ADDENDUM NO. 4

TO: PLANS AND SPECIFICATIONS FOR STATE OF MISSOURI

Renovate Mechanical / Electrical / Life-Safety / State Office Building
Jefferson State Office Building
205 Jefferson Street
Jefferson City, MO 65101
PROJECT NO. O1911-01

SHEET NUMBER:
M3.1
95 OF 244 SHEETS

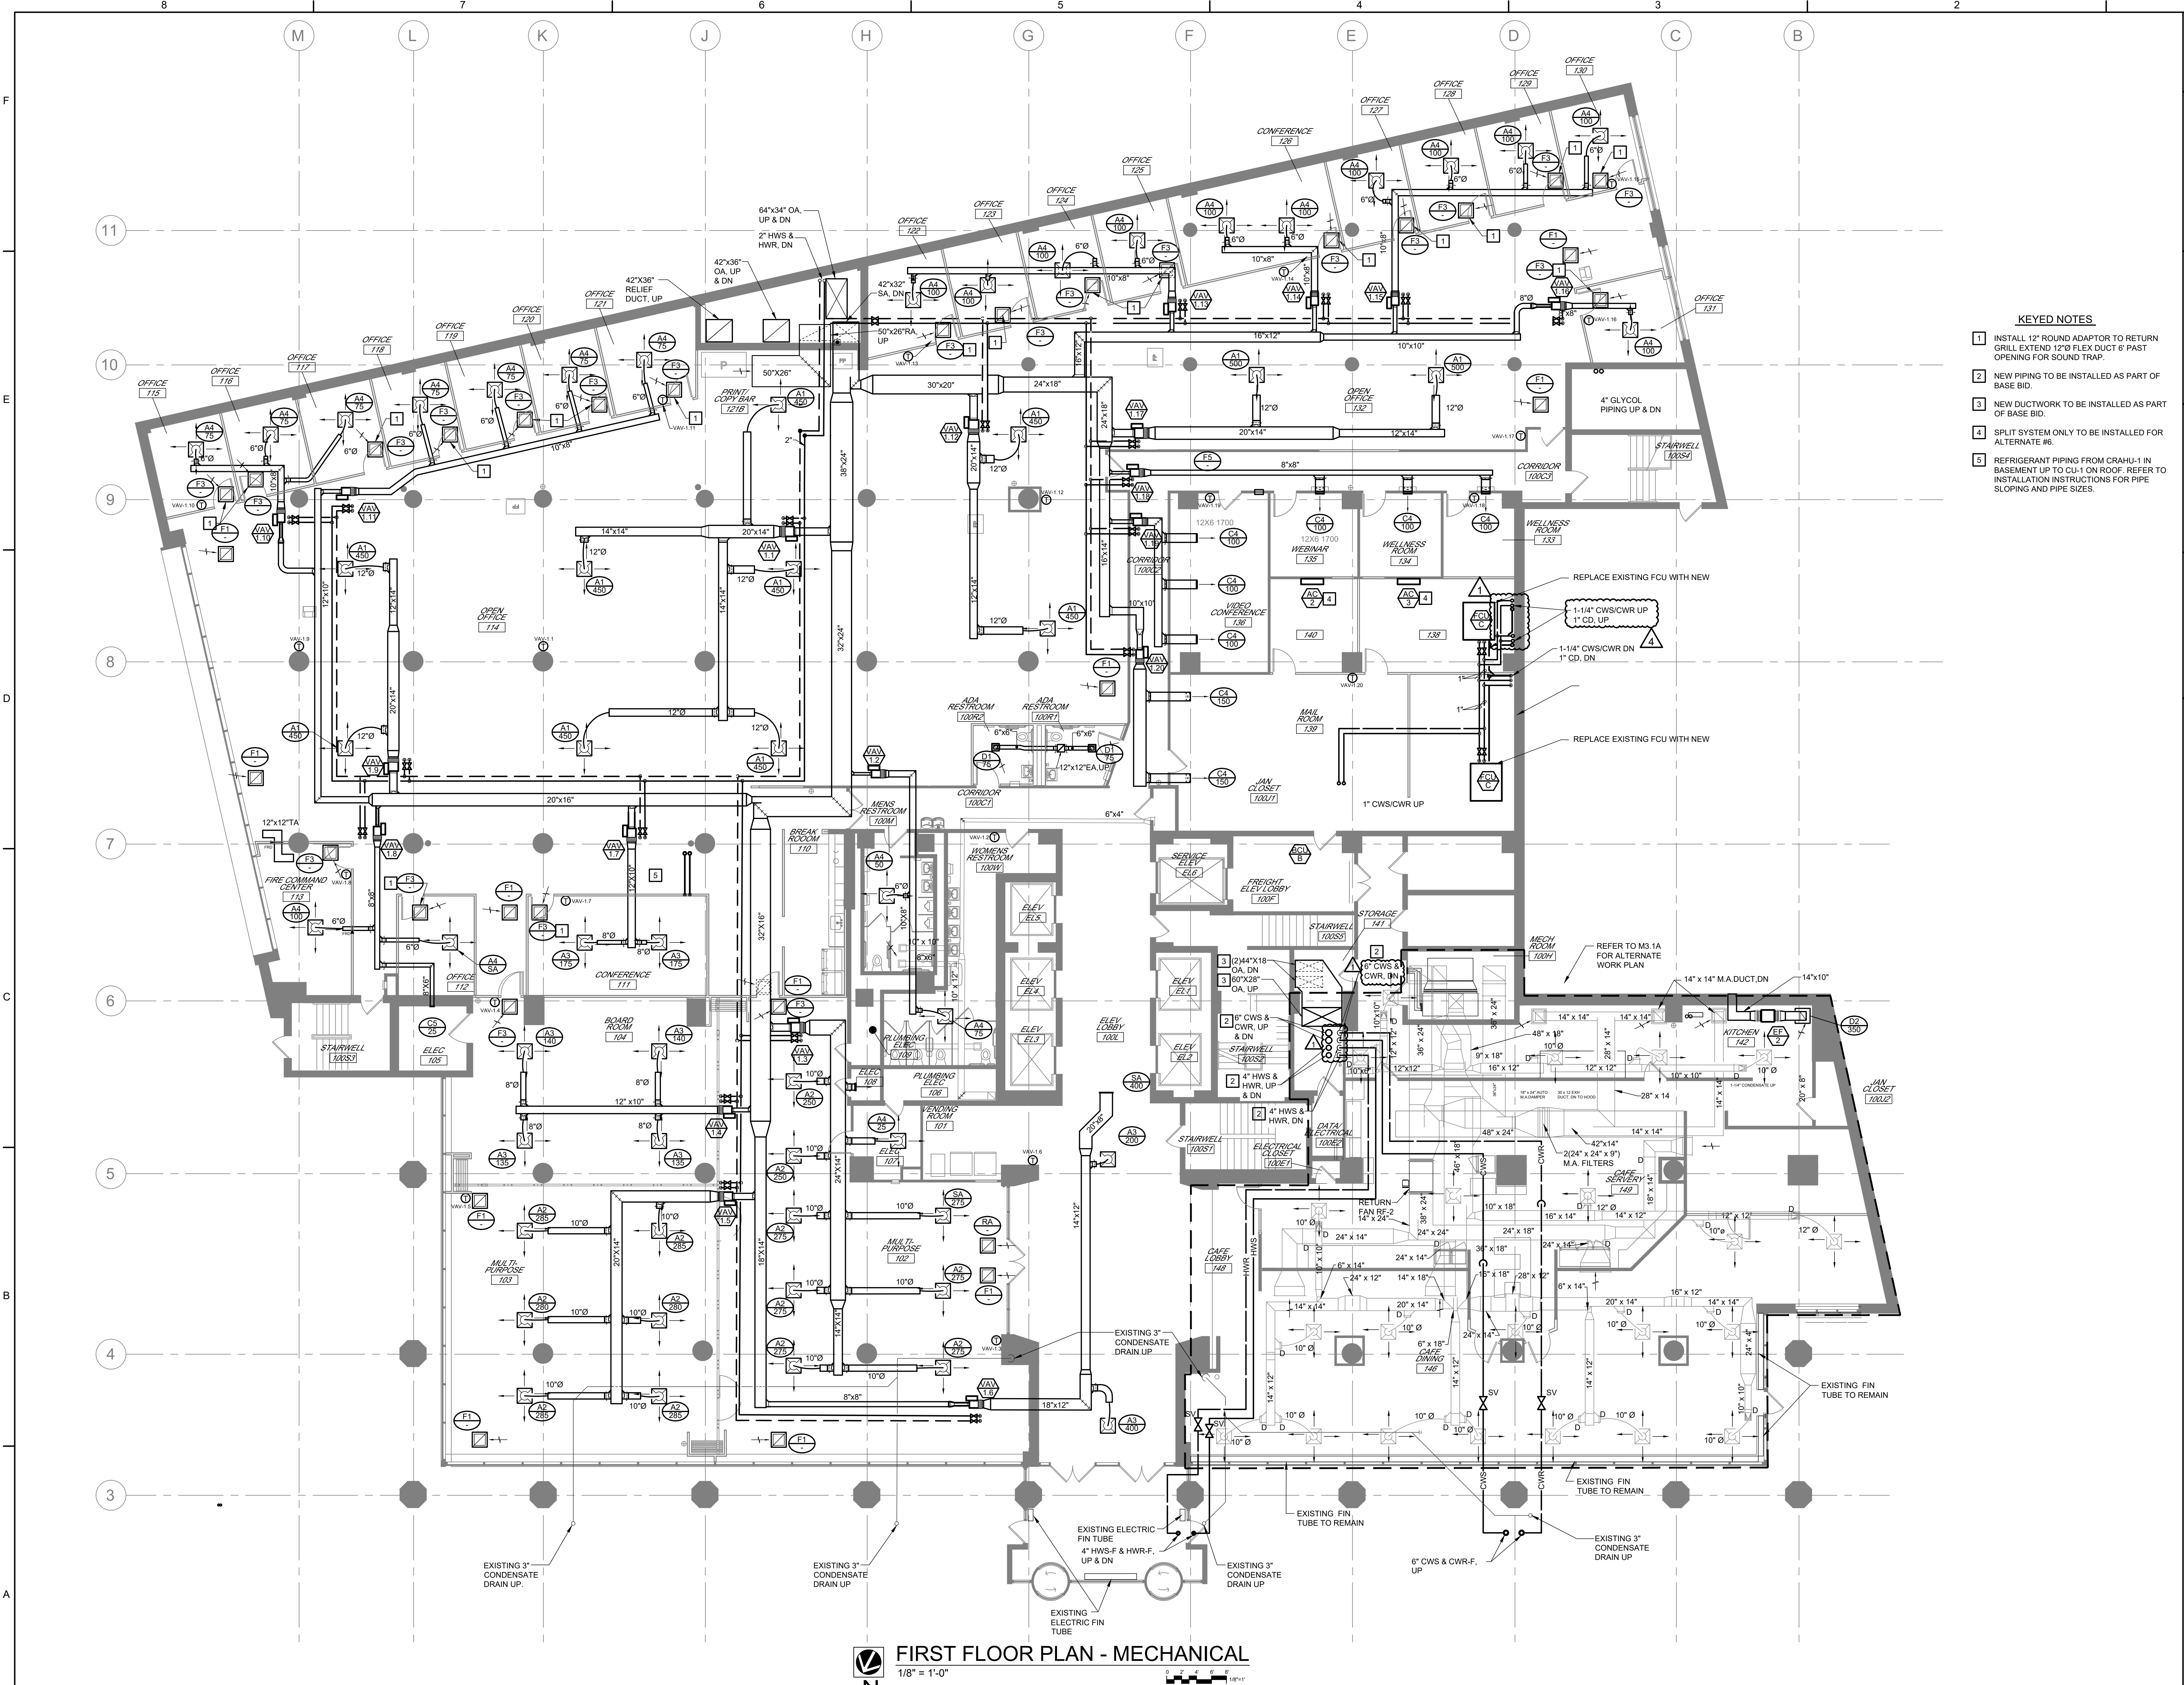
8. Drawing M3.0:
 - a. **UPDATED** – to show correct pipe size.
 9. Drawing M3.1:
 - a. **ADDED** – Piping to FCU-C.
 - b. Clarified Riser Size.
 10. Drawing M3.1A:

- d. VAV3.4 is on the plans but not scheduled. Please advise.
Response: VAV3.4 added to schedule.
- e. Sheet M3.1 Freight Elev Lobby 100f – Please confirm if BCU-B is required. There is an equipment tag shown, but no equipment or piping shown.

Response: Confirmed - There is only 1 BCU-B and it is located adjacent to elevator lobby see sheet M3.2
- f. Sheet M3.2 – There is no piping shown feeding two FCU-E's in the mechanical room adjacent to the loading dock.

SHEET NUMBER:
M3.2
97 OF 244 SHEETS

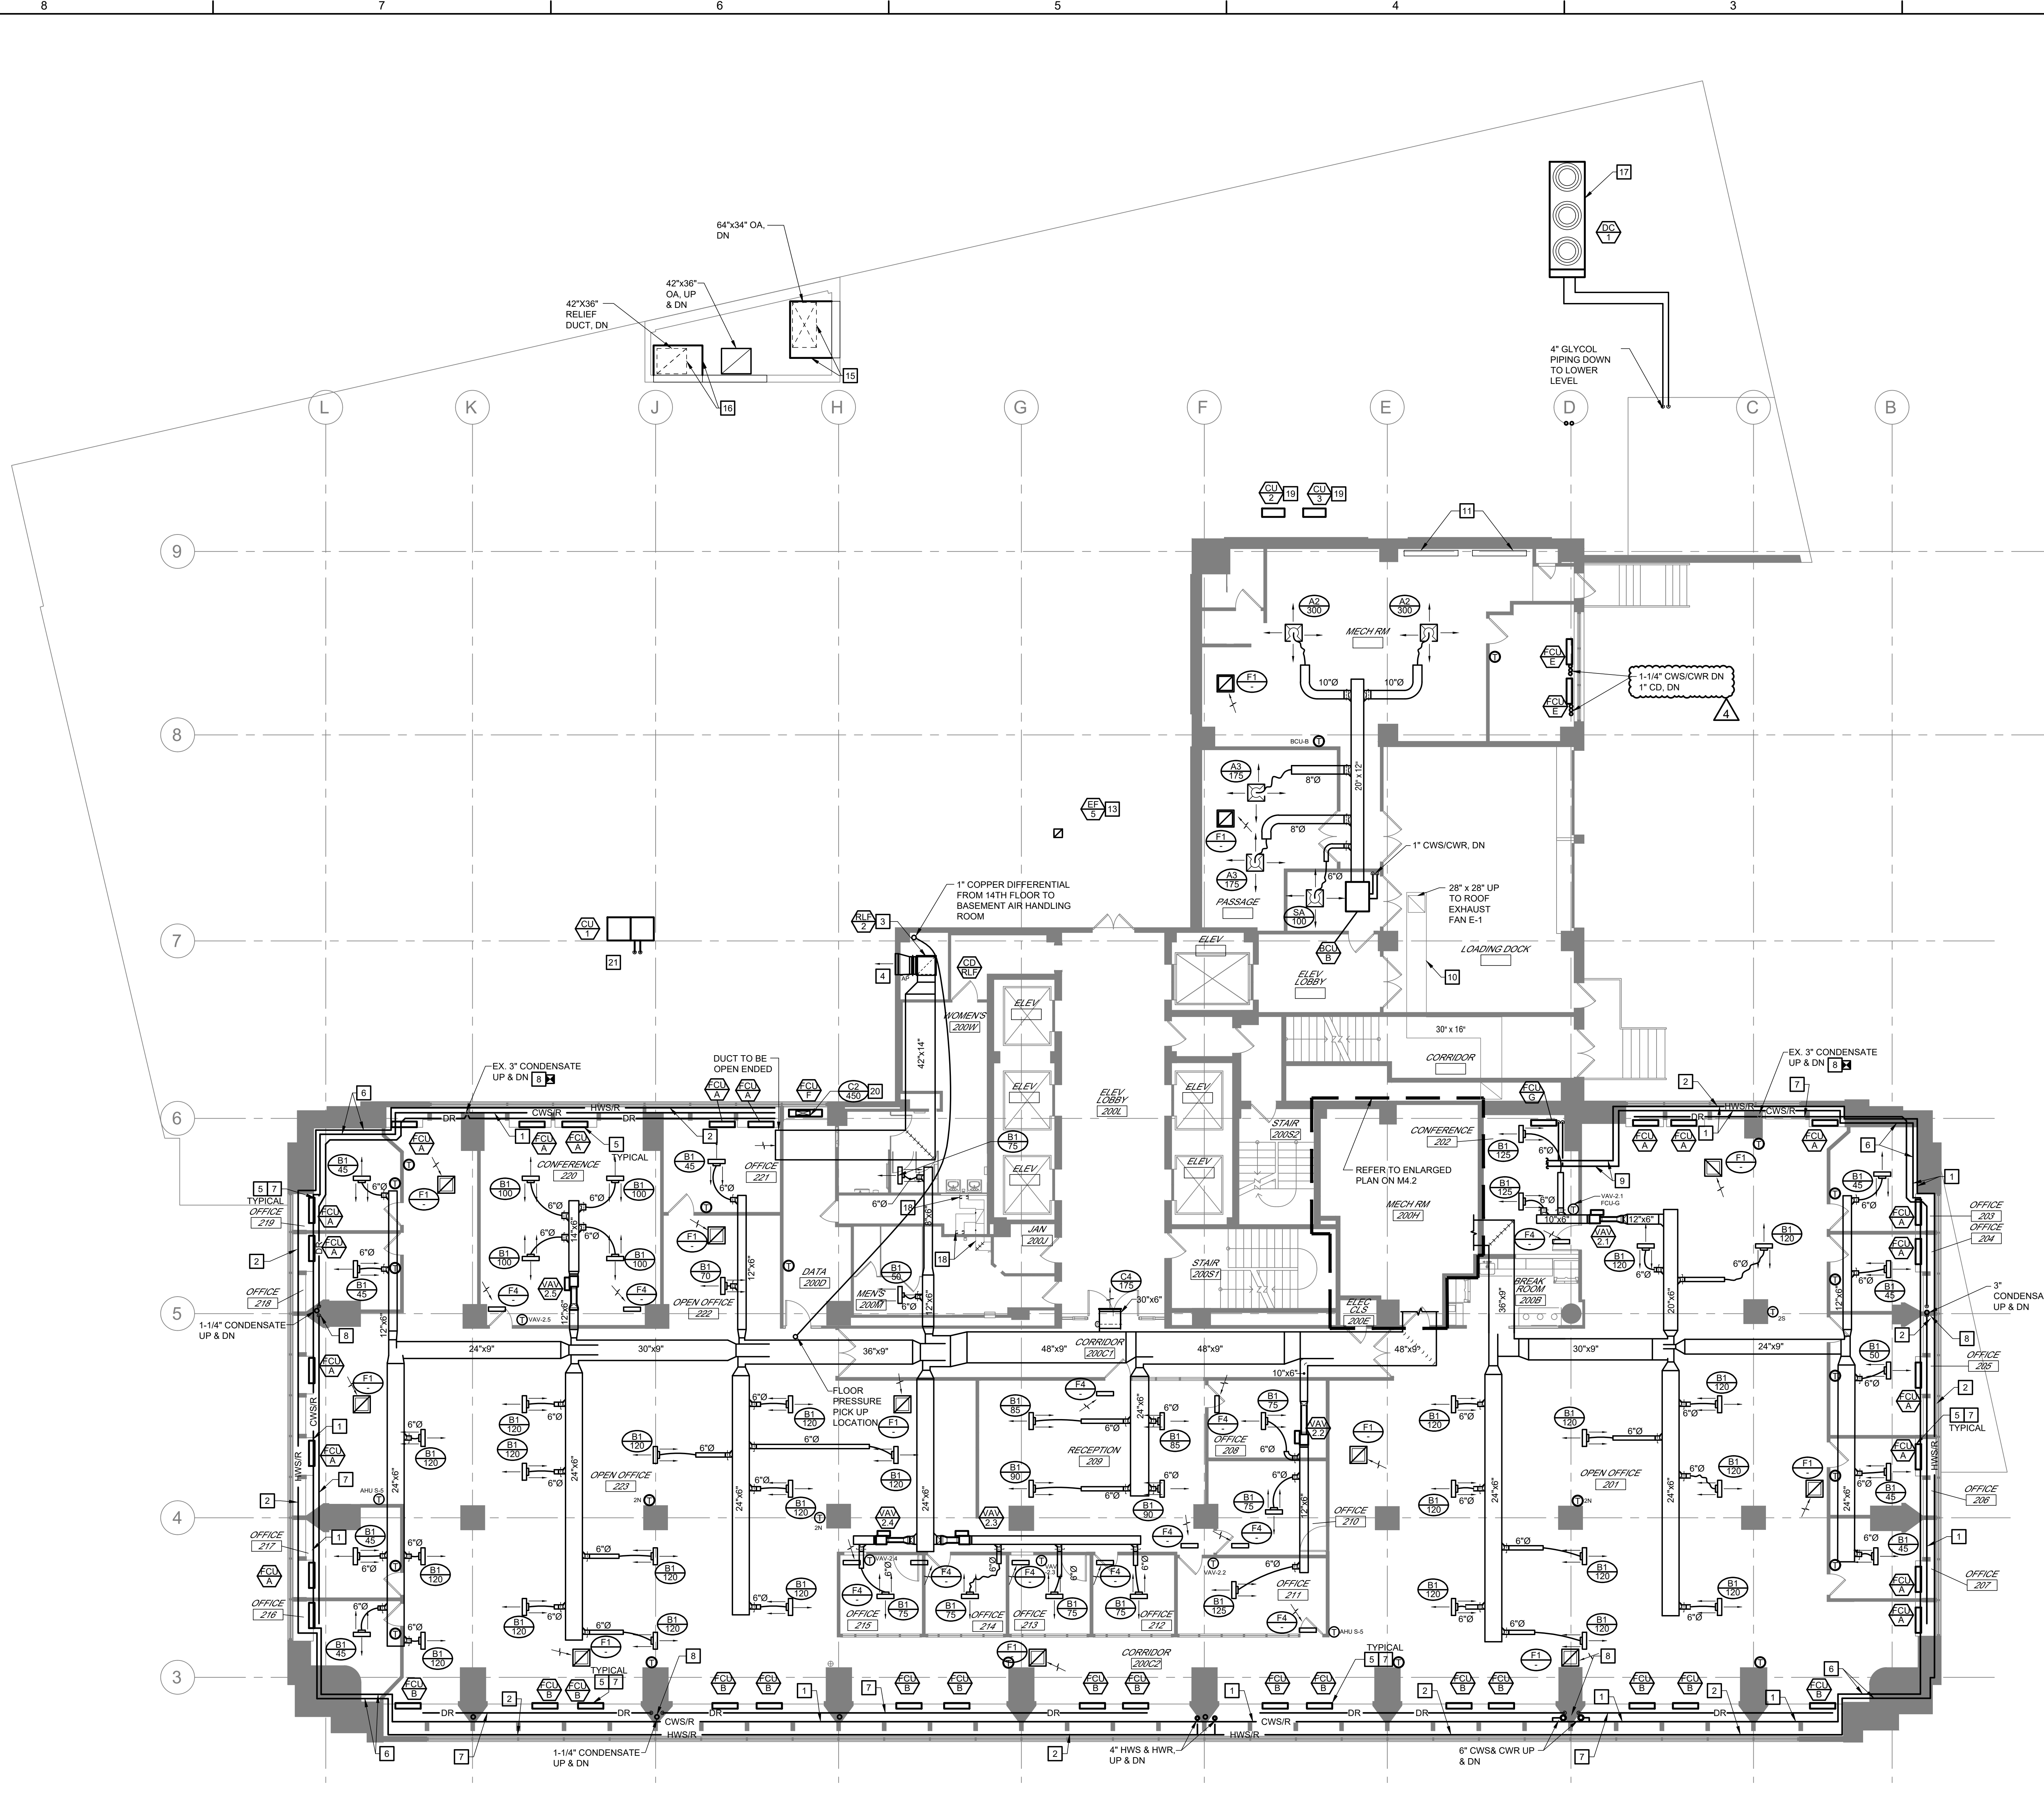
- a. **ADJUSTED**- Pipe Riser Size.
 11. Drawing M3.2:
 - a. **ADDED** – Piping to FCU-C.
 12. Drawing M3.14:
 - a. **ADDED** – House Keeping Pad
 13. Drawing M4.0:

Response: Plans updated to include piping to FCU-E.
- g. Can you provide a schedule for the dx coil located in the penthouse?
Response: Schedule has been added to sheet M6.4
